61-34285-20
03-34285-01/-02/-03/-04/-05/-06/-07
61-37770-00
03-37770-01/-02/-03/-04/-05
MERCEDES-BENZ

OM 457/OM 460

The OM 457 and OM 460 series of engines starting at engine number 085588 make use of modified cylinder heads.

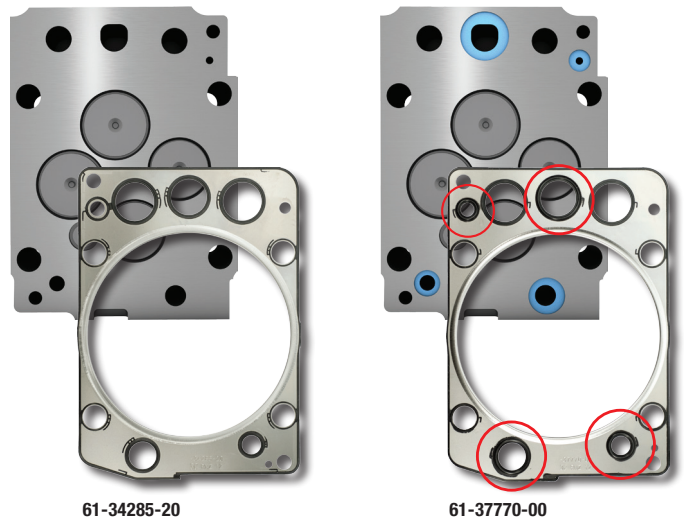
While the previous cylinder head has an even sealing surface, the modified design features a groove milled out around the drillings for water/pressurized oil. The cylinder-head gasket was adjusted to increase its sealing capacity.

The main features which distinguish cylinder head gasket are that the rubber gasket lips of the drillings for water/pressurized oil are about 3 mm higher.

61-34285-20_Even rubber gasket lip

61-37770-00_3 mm higher rubber gasket lip

Cylinder head with even sealing surface. Up to engine number 085588
61-34285-20 (cylinder-head gasket) or **03-34285-XX** (cylinder-head gasket set)

Cylinder head with grooves milled in. Starting at engine number 085589
61-37770-00 (cylinder-head gasket) or **03-37770-XX** (cylinder-head gasket set)
